Migrating from PE9704 to PE97042

Migrating From PE9704 to PE97042

Figure 1. Pin 28 configuration differences between PE9704 and PE97042

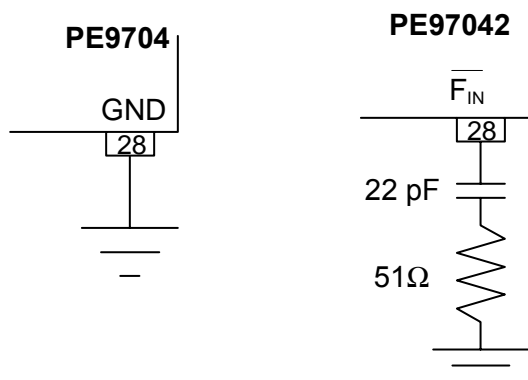
Migrating from PE9704 to PE97042 requires one change to the way pin 28 is connected. Pin 28 is “GND” in PE9704 but is “ \overline{F}_{IN} ” in PE97042. Instead of tying pin 28 directly to “GND” as is in PE9704, pin 28 for PE97042 needs to have a 22 pF capacitor in series to a 51 Ω resistor to “GND” as shown in *Fig. 1* below.

Figure 3. PE97042 Pin Configurations (Top View)

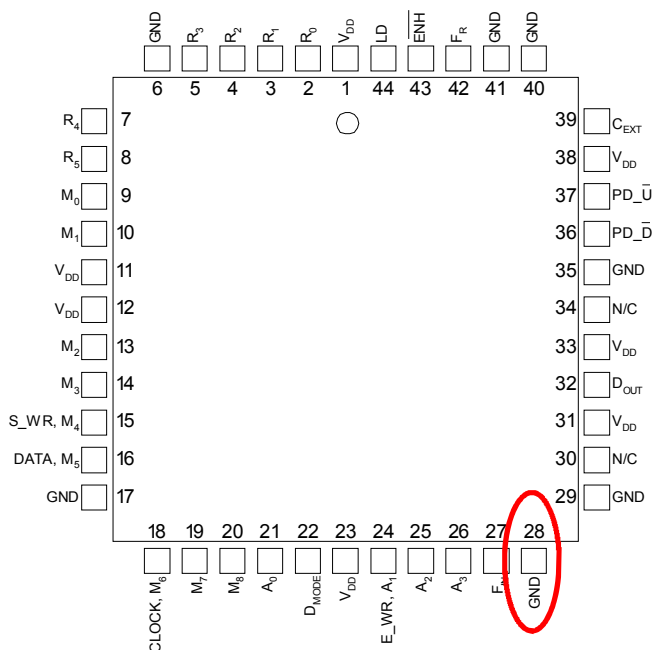
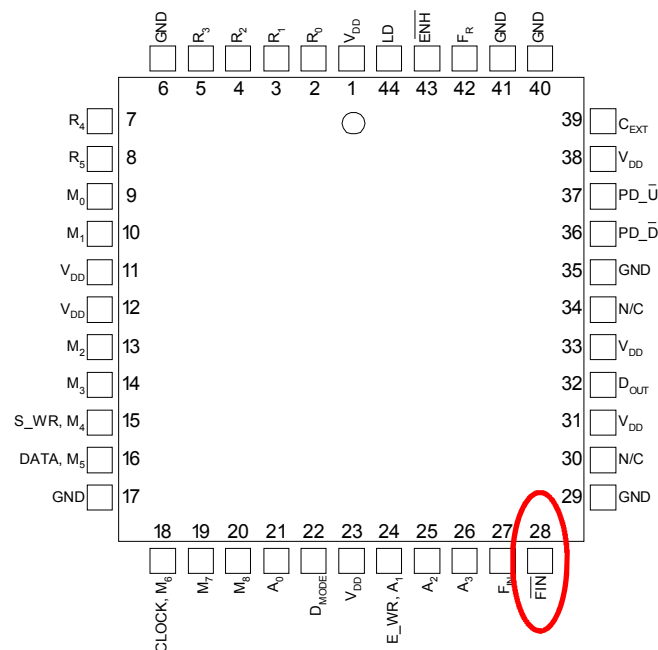
Pin 28 is the only pin difference between PE9704 and PE97042, which requires board modification. There is no other pin difference. PE97042 can operate at 3.0 V nominal V_{DD} and benefit from the lower phase noise but the phase noise can be further improved by raising the V_{DD} supply level to 3.3V. See *Fig. 4* for a comparison between the Typical Phase Noise levels for the two parts.
